Re : Modification No. 166.2/2010, 368 Hamilton Road & 80-84 Tasman Parade Fairfield West –
 Dual Key Apartments & parking

Re : Modification No. 166.2/2010, 368 Hamilton Road & 80-84 Tasman Parade Fairfield West

Re : Modification No. 166.2/2010, 368 Hamilton Road & 80-84 Tasman Parade Fairfield West – Dual Key Apartments & parking

Diagram showing potential density

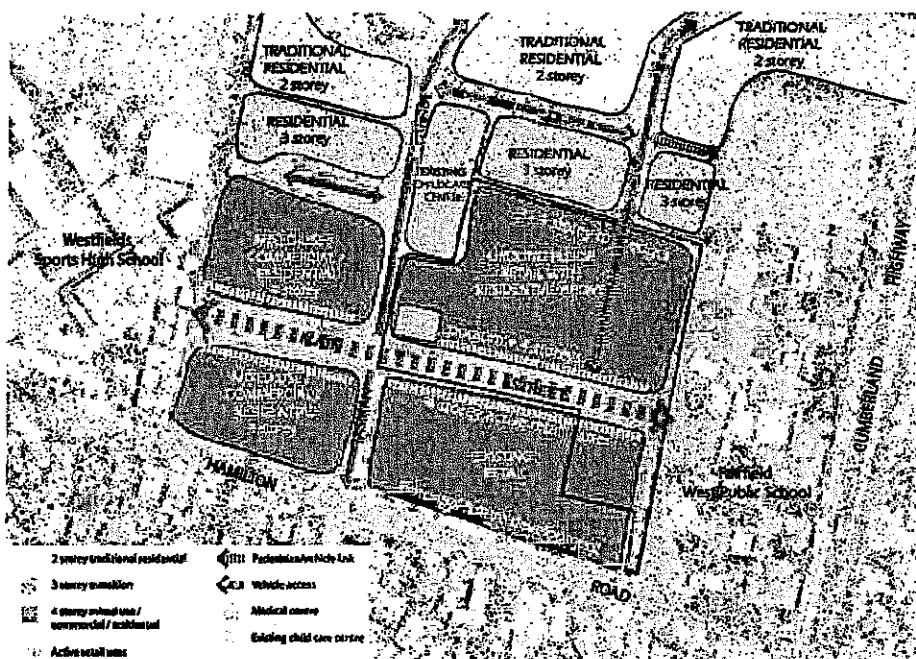
The following diagram explores a potential approach to the surrounding streets to allow for slightly greater density and scale and in doing so amalgamating sites to allow a full public address to both schools with clear wayfinding and safe access. The sites to the north are also reviewed for slight increases in scale given their proximity to the centre and the intent of the development to connect Baudin Crescent to the retail and schools.

The above diagram submitted as part of the original DA is an appropriate strategic planning and urban design based solution to making a reality of the potential of the existing centre as core of a local centre supported by logical and appropriately scale residential development as a transition to the existing low density context top the north. The pedestrian link between the podium and Baudin Crescent is now reinstated as indicated in red above.

PROJECT	PROJECT NO.	DRAWING	SCALE @A4	REVISION / DATE	DRAWING NO.
TASMAN COURT	243.1	TYPICAL PROPOSED 3 BEDROOM DUAL KEY	1:100	ISSUED FOR S96 17/09/2012	149

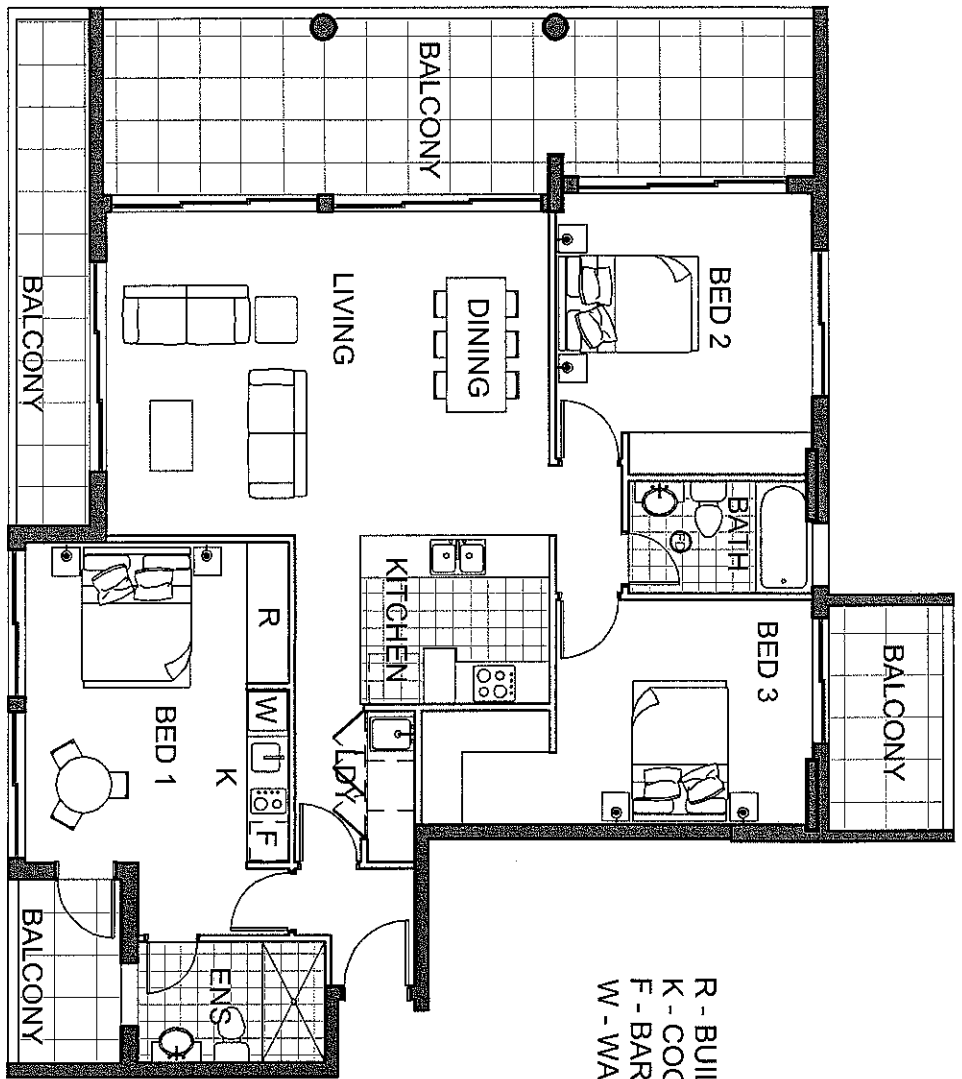
It is proposed to market the dual key units as an option in the fitout of 2 or 3 bedroom units. The inclusions being a kitchenette; consisting of a sink, bar fridge and bench top. The ensuite bathroom and bedroom remain part of the design of a 2 or 3 br apartment whether or not it has a dual key fitout.

- The cultural preference for accommodation of extended family members 'under the same roof' but not necessarily sharing all the same rooms.
- The accommodation of unrelated people in a 'flat sharing' arrangement.
- For the owner of the unit to have the flexibility to achieve either of the above outcomes to generate rental income to help pay the mortgage or alternately, to use the apartment as a 2 or 3 br / 2 bathroom dwelling. This flexibility is shown on the attached 2 and 3 br unit layouts showing inclusions.
